# USE ON REVIEW REPORT

▶ **FILE #:** 12-H-19-UR **AGENDA ITEM #:** 19  
 POSTPONEMENT(S): 12/12/2019 - 1/9/2020 **AGENDA DATE:** 2/13/2020  
 ▶ **APPLICANT:** MARK RANDOLPH / RANDOLPH ARCHITECTURE  
 OWNER(S): Leslie Barrett

▶ **APPROVE the Use on Review for a 120 room hotel in the O-1 (Office, Medical and Related Services) district, subject to 9 conditions.**

PROJECT: UPSCALE WORLD'S FAIR PARK HOTEL  
1100 CLINCH AVENUE  
DISTRICT 4, WARD 15, BLOCK 10402  
KNOXVILLE, TENNESSEE

USE ON REVIEW SUBMITTAL  
12-H-19-UR  
**UOR1.01**

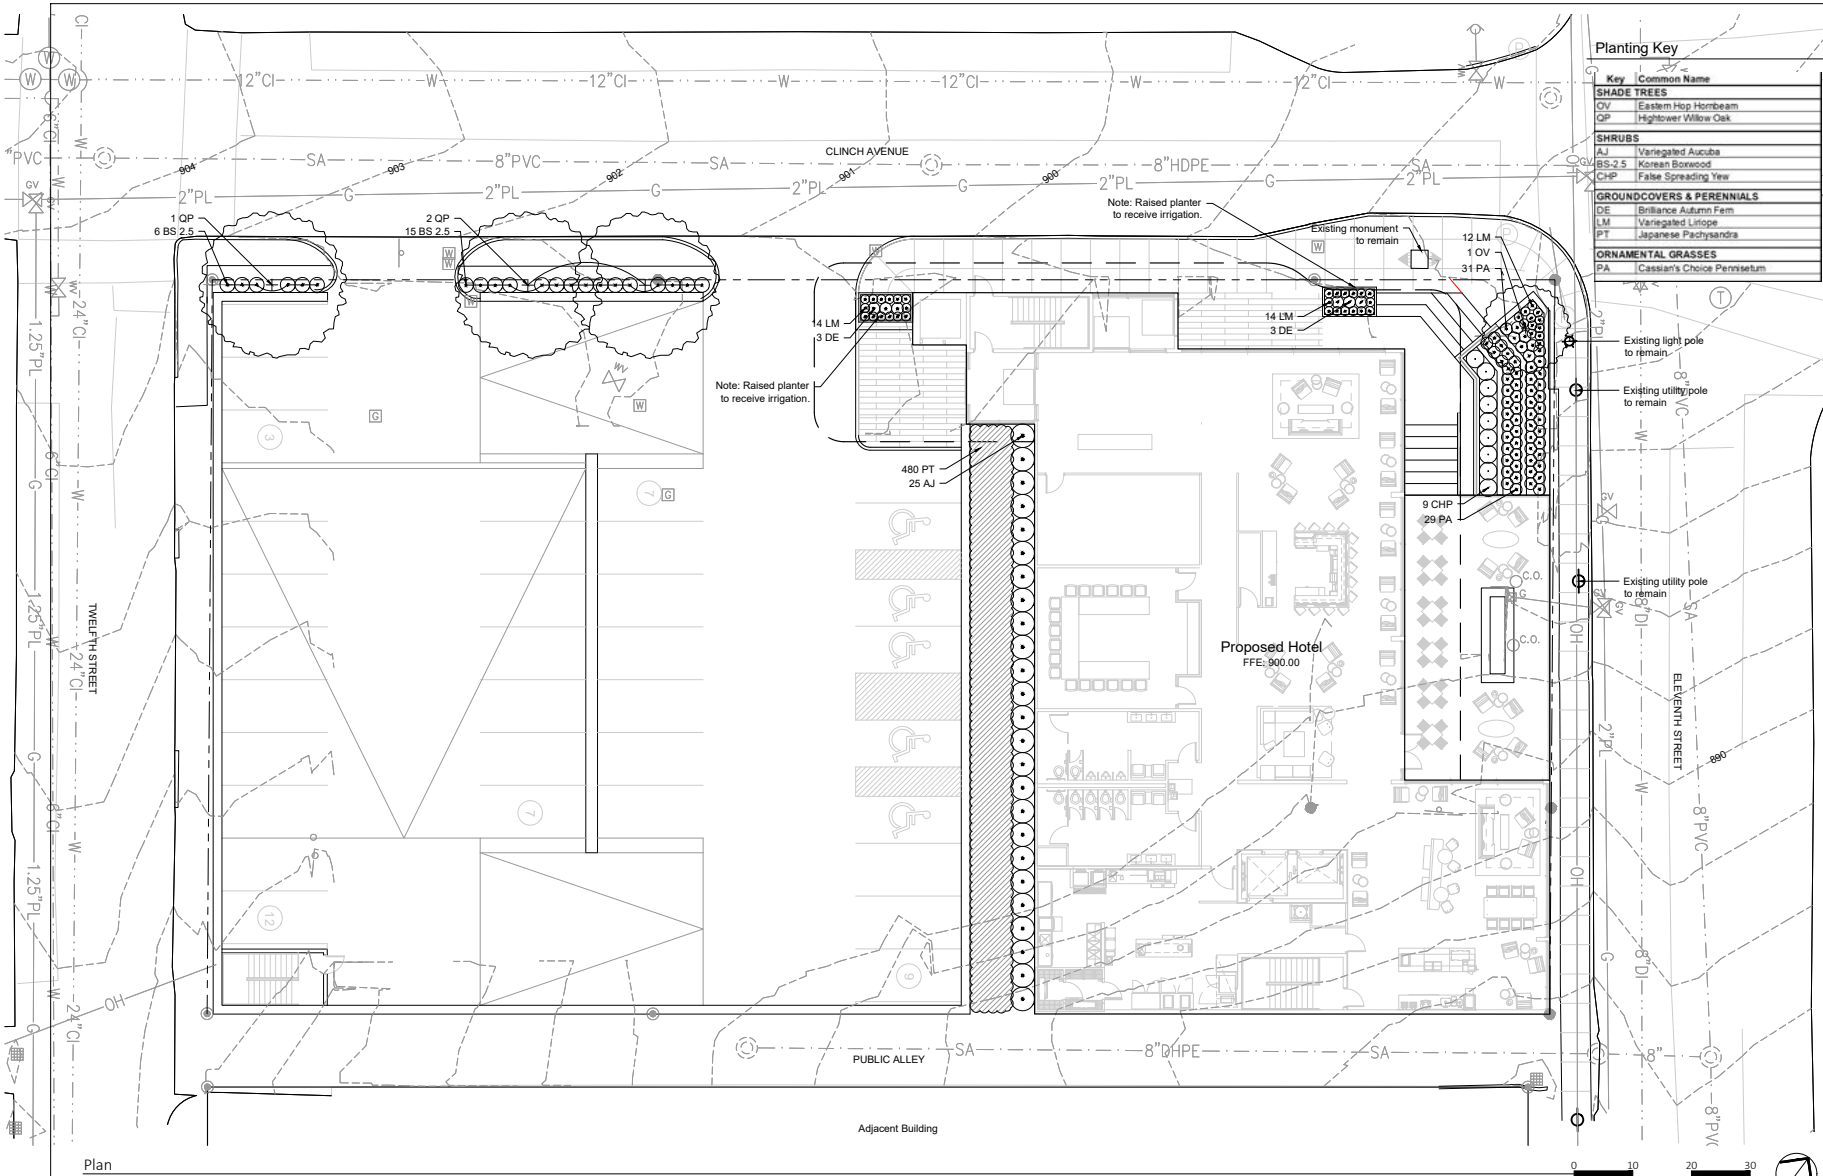
5. Installing all sidewalks and crosswalks shown on the development plan in accordance with the requirements of the Americans with Disabilities Act (ADA) and the City of Knoxville Department of Engineering.

7. Meeting all applicable requirements of the Knoxville Utilities Board regarding the building setback requirements from the above ground electrical lines.

8. Meeting all applicable requirements of the City of Knoxville Department of Engineering.
9. Meeting all applicable requirements of the City of Knoxville Zoning Ordinance, including but not limited to the standards for canopies extending over a public sidewalk.
